SWINDON PARISH COUNCIL

PLANNING APPLICATION COMMENTS

Planning Reference:	20/00759/FUL	Application Date:	25 th February 2021
Application Title:	Demolition of a dwelling and the erection of 265 dwellings (Use Class C3), new vehicular and pedestrian access off Manor Road, attenuation basin and ancillary infrastructure.

Figure 2: Entrance to Dog Bark Lane

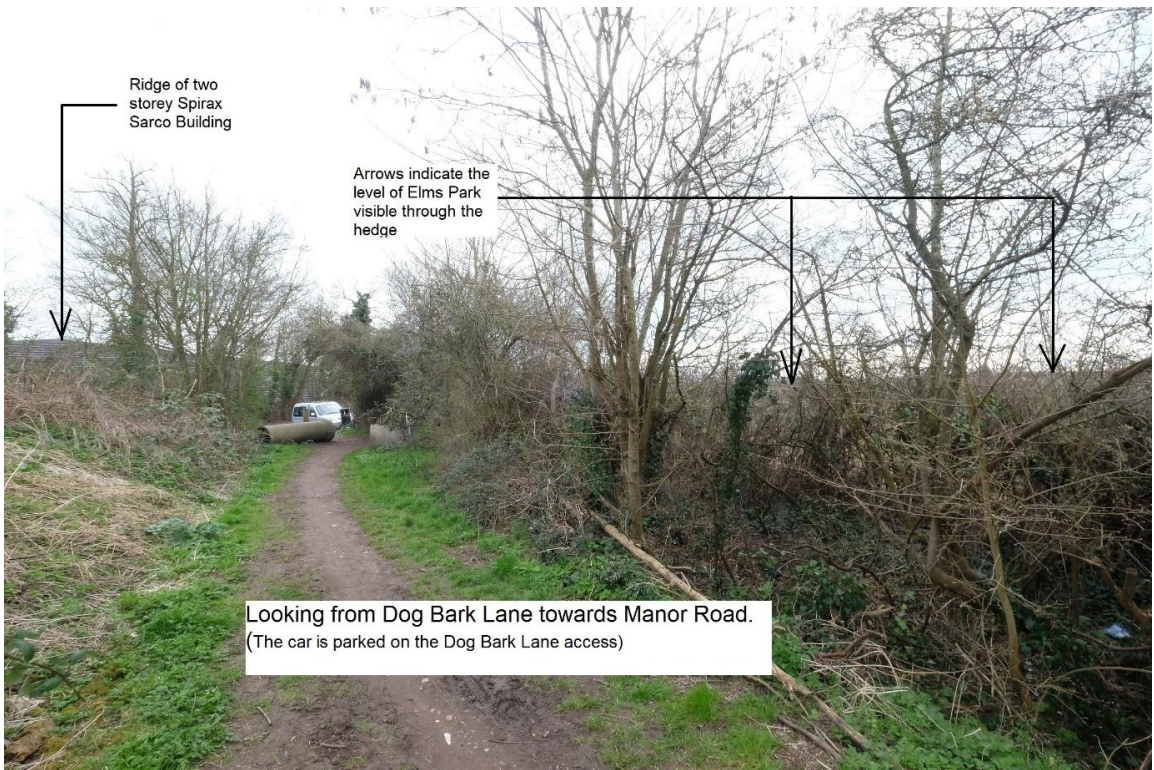
4.2.2 Figure 1 to Figure 5 illustrate that the point that Dog Bark Lane has a very rural character despite the access being located on the opposite of Manor Road from Spirax Sarco. At the junction of Dog Bark Lane with Manor Road there are almost no visual references to the wider commercial elements along Manor Road and Runnings Road. We firmly believe that this location is an extremely important and sensitive link between Elms Park and Swindon Village and therefore the houses proposed for Dog Bark Lane should reflect a residential and varied character similar to those in new residential developments in other areas such as Winchcombe. We also believe that the blocky style is inappropriate.
